Mack Trucks, Inc. Greensboro, NC USA

Clutch Pedal Micro Switch, Replacement CHU, CXU, GU, TD

PI0861, Clutch Pedal Micro Switch, Replacement

(October 2015)

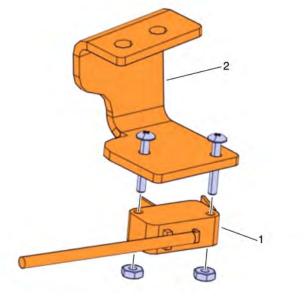
On Certain MACK CHU, CXU, GU, and TD Trucks built between 07/06/2009 through 09/26/ 2014, equipped with "Engine Start Condition, Clutch Pedal Fully Depressed" feature and has a relay center Electronic Power Distribution Module (EPDM) gasket (part number 82732384) installed, may experience interference between the clutch pedal micro switch and EPDM gasket. To prevent interference between the clutch pedal micro switch and the EPDM gasket, replacement of the clutch pedal micro switch and micro switch mounting bracket is required. Follow the replacement procedure outlined in this PI (Product Improvement).

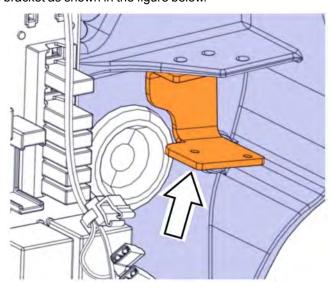
17 Position the new micro switch mounting bracket (part number 84701803) on the driver control module bracket as shown in the figure below.

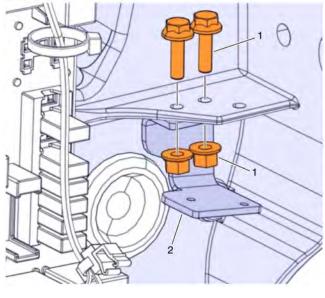
18 Using the stored fasteners (1), secure the micro switch mounting bracket (2). 19 Using hand tools, tighten the fasteners to 10 ± 1.5 Nm (88 \pm 13 in-lb).

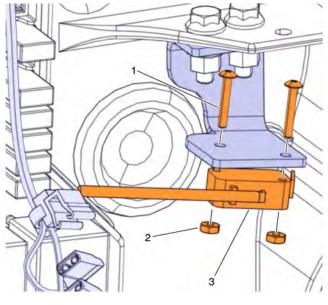
- 20 Position the new (part number 22668899) clutch pedal micro switch (3) on the mounting bracket and install the stored fasteners (1) and (2).
- 21 Using hand tools, hand tighten the fasteners.
